SEPTIC SYSTEM APPLICATION	PERMIT NO. 4562
FLATHEAD COUNTY	SANITATION OFFICE
1 Las 14 Country Village #	2
Legal Description of Property	Parcel Size
Legal Property Owner	Property Occupant
5 C/2 Mery Ath Elm 136 Decreased	Ew 554 Country (1 by no Kal)
Address & Phone 752-3069 Kal.	Property Address

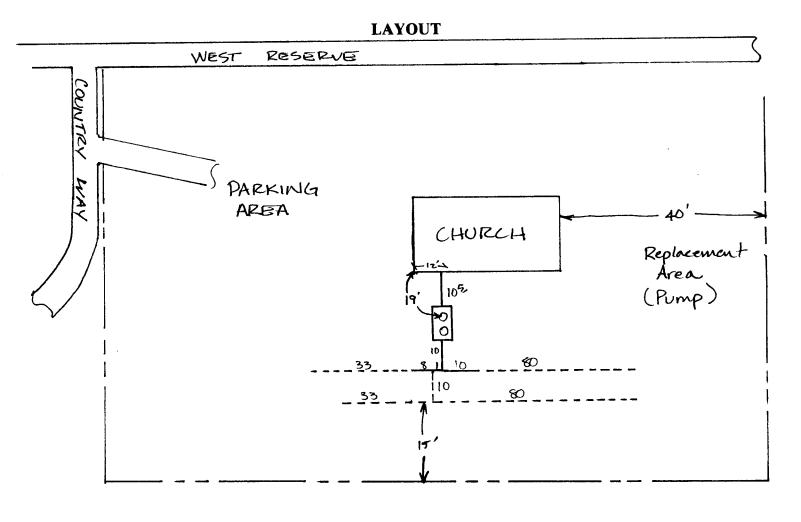
4. Absorption Area: 66050. FT.	=> 6605a.Ft. of
	absorption area.
4	
Describe Drainfield: USE 370 L.F. 0F	ZFT. WIDE TRENICH OR
	PENCY, KEEP THE
	HAD NO DEEPER THAN
36 INCHES.	
PROPOSED DRAINFIELD S	SITE IS SOUTH AND SOUTH-
EAST OF TITE BUILDING	? BE SURE TO LEAVE
ENOUGH SPACE FOR	A 100% PEPLACE MENT
AREA. DREEDRABLY B	ZOW THE OFIGINAL
DRAINFIELD

Date 8/26/86	Inspected by
Approved	Disapproved*
Inspector Comments 1)	of 226 LF of 2 ft wide trenches (452 ft2) a will probably require pump system. Trench 5:0-12" silt lam 12"-36"+ med grained sand.
Replacement are	a will probably require pump system. Trench
denth 3ft Soil	5:0-12" silt lan 12"- 36"+ med. wained sand.
	-
	Name of Installer Stillwater Quelens
	Name of Installer: Stillwater Quedors
